Re: Environmental Protection Agency's (EPA's) "Petroleum Refinery Sector Risk and Technology Review and New Source Performance Standards: Proposed Rule" at 79 Fed. Reg. 36880 (June 30, 2014).

The American Petroleum Institute (API) and the American Fuel and Petrochemical Manufacturers (AFPM) submit the attached comments on the Environmental Protection Agency's (EPA's) "Petroleum Refinery Sector Risk and Technology Review and New Source Performance Standards: Proposed Rule" at 79 Fed. Reg. 36880 (June 30, 2014).

EPA has proposed, in one administrative package, significant and precedent-setting changes to two of the major rules that apply directly to refineries -- part 63 subpart CC (RMACT 1) and part 63 subpart UUU (RMACT 2). At the same time, EPA is implementing a policy and regulatory framework in response to the *2008 Sierra Club* court decision, which overturned the generic startup, shutdown, and malfunction exemption in part 63. Although this rulemaking package

Figure 12. Mislocated sources extending closer to cancer MIR than refinery equipment, as calculated using HEM-3

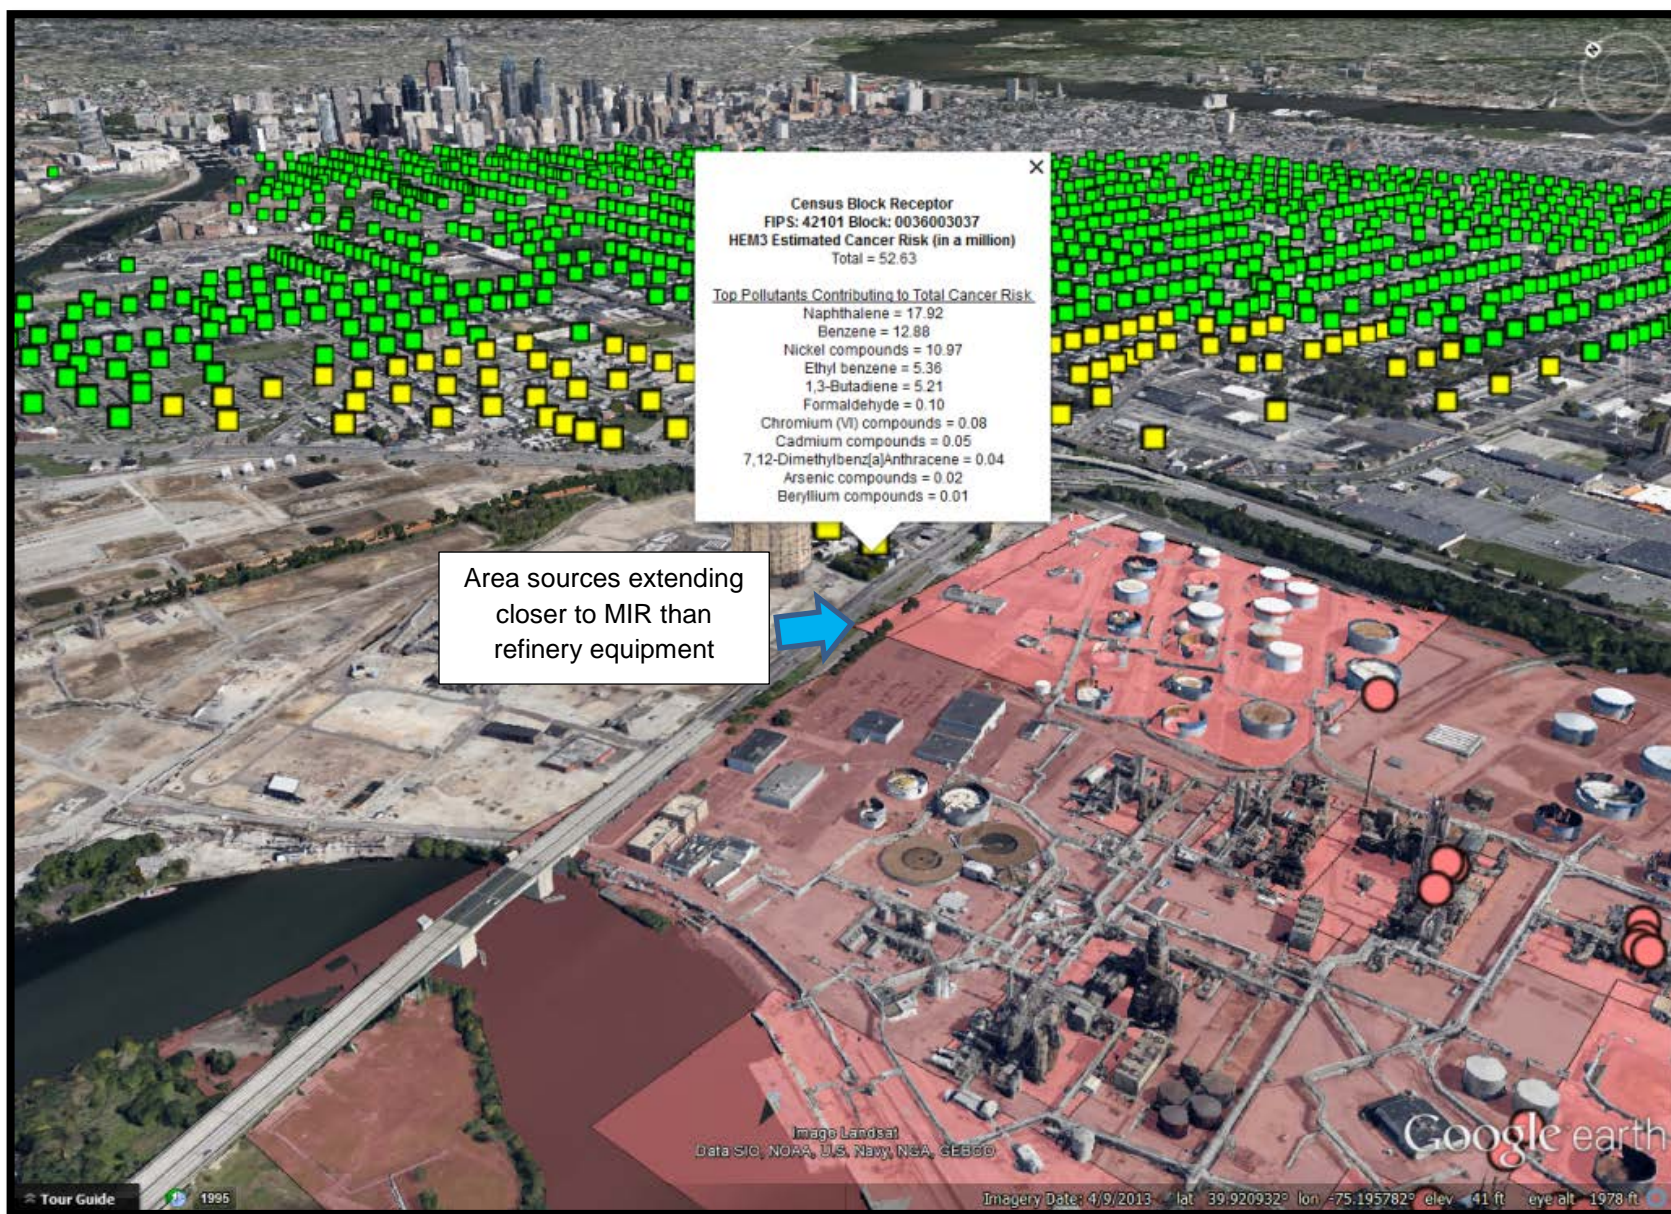
The fifth highest modeled facility-wide cancer MIR was reported by EPA to be 53 in a million for refinery NEI40723. Figure 12(a) shows the location of the modeled cancer MIR calculated by HEM-3. Figure 12(b) shows several area sources that extend nearer to the modeled cancer MIR location than actual refinery units. Another view of the extension is shown in Figure 13. To the extent that this extension causes modeled emissions to be released closer to the cancer MIR location than is actually the case, that risk would be calculated as higher than it otherwise would be.

Detailed analysis of HEM-3 modeling results calculated that 15 of the 53 in a million risk at the modeled cancer MIR was attributed by HEM-3 to emissions of naphthalene from an area source designated by EPA as MEPE0060.

Comparison of naphthalene emissions from that source with refinery naphthalene sources elsewhere caused that source to be flagged as a possible emission outlier. As shown in Figure 14, that source is listed in the EPA refinery emission inventory database as the 6th largest source of naphthalene emissions of the nearly 12,000 naphthalene sources in the database.

Similarly, comparison of benzene emissions from that source with refinery benzene sources elsewhere caused that source also to be flagged as a possible benzene emission outlier. Figure 15 shows that the EPA refinery emission inventory database lists refinery NEI40723 as having the 1st, 4th, 11th, 13th (MEP0060), and 14th largest calculated benzene process equipment leak sources of the more than 2,000 such sources in the database.

Further verification of the emissions from these key risk-driver sources is warranted. If corrections are appropriate, re-modeling of corrected source emissions and locations using HEM-3 is warranted.
